FINAL ORDER

Special Standards Request Form

(7) Address of Project/Well Site: Near 25805 SE Dowty Rd, Eagle Creek, OR 97022

(8) Type of Work (New, Deepening, Alteration, Abandonment): Abandonment

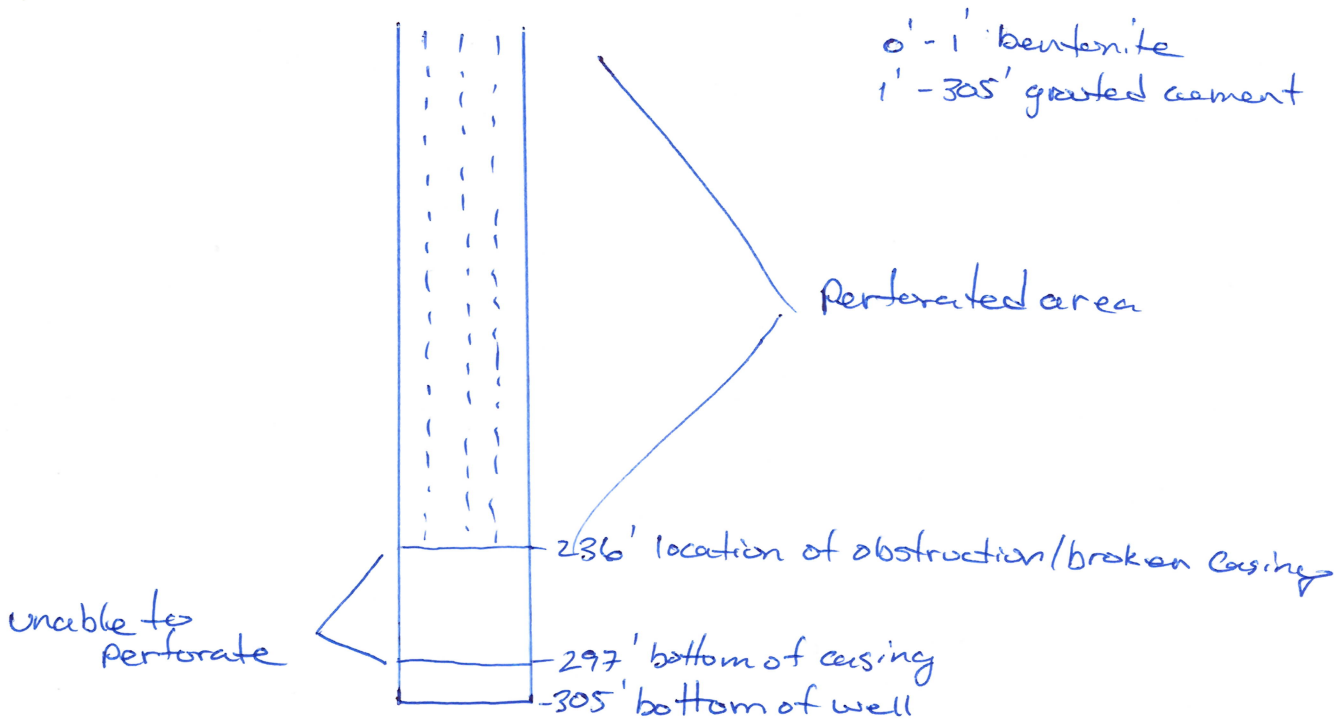
(10) The Unusual Site Conditions Which Necessitate this Request: Unable to perforate casing from

236' to 297' due to an obstruction/broken casing @ 236'.

Cement will be pump in from the bottom of the well in the area we are unable to perforate.

The Special Standards Request Form you submitted for landowner: Metro Parks and Nature, Start Card number: 1083347, is hereby approved for the following: You may decommission this water supply well as outlined on your Special Standards Request Form dated September 15, 2026. All other well abandonment standards apply as required under Oregon Administrative Rules 690-220. A copy of your Special Standards Request Form is enclosed.
